**Subject: Expert Report - White / Campbell versus FCA, et al**

In support of the subject litigation I am submitting an Expert Report in compliance with the narrow disclosure requirements of Rule 26(a)(2)(B) - i, ii, iii, iv, v and vi:

**Applus IDIADA KARCO Engineering, LLC – Test Report Number : TR-P38306-01-NC**

Page 3 – Comment 4 above, fuel pump access panel:

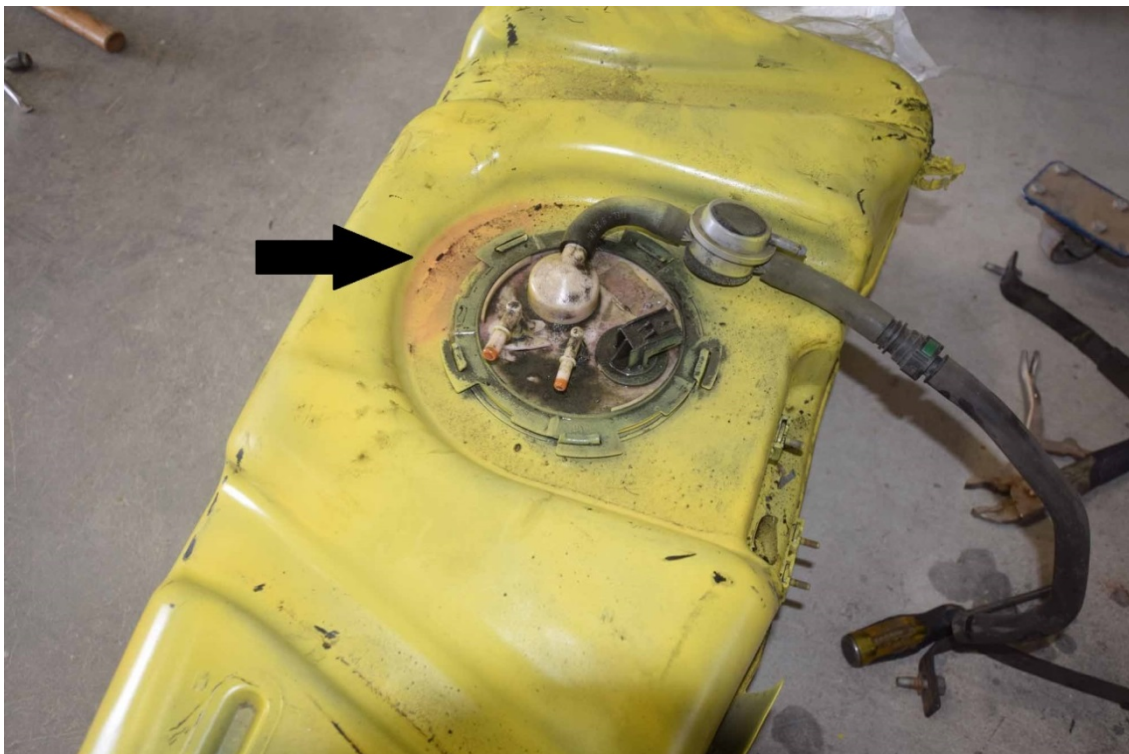
Page 3 Comment 2	Undersigned agrees with, “. . . the odor of Stoddard solvent was present.”
Page 3 Comment 3	Undersigned agrees with, “The amount of solvent observed was immeasurable..”
Page 3 Comment 4	<p>Page 3 paragraph 2, the undersigned was present throughout the post-test inspection, conducted on December 21, 2018.</p> <p>Report verbiage, “Upon removal of the FTEP and the fuel tank from the vehicle, a plastic output nipple on the top of the fuel tank was found cracked.”</p> <p>Two possibilities for this condition were proposed/reviewed:</p> <p>(1) Minor crack occurred during the crash test, provoking attention to an additional Jeep Liberty KJ issue.</p> <p>(2) Initial inspection of the fuel tank and pump assembly confirmed that these 16 year old components had never been removed/serviced.</p> <p>During a two-fold Karco removal/re-install of the fuel tank, the fuel pump access panel was not utilized. Karco technicians later admitted strain/difficulty with fuel pump liquid/electrical lines. It is possible that minor stress crack in the <b>plastic</b> fuel outlet nipple occurred during this difficulty. Crack is shown in report photos #131, #132, #133, #134, #135, #136, #137, and #138, which were taken at the post-crash inspection. It is possible that the crack did not occur during the crash test. Competitive use of <b>steel</b> fuel pump assembly, including <b>steel</b> nipples, such as used by Ford on vehicles such as the Crown Victoria, would have eliminated this additional KJ issue..</p> <p>The minor fumes that were present post-test appeared to originate from top of tank, where no crash ignition sources are present. No other tank surface had Stoddard staining. Photographs of Fuel Pump Assembly Access Panel and minor top of tank Stoddard trace-staining attached below.</p>

Page 3 – Comment 4 above, Stoddard trace-staining restricted to top-of-tank only, post crash test inspection confirmed that no other tank surface location had staining and were completely dry/intact:
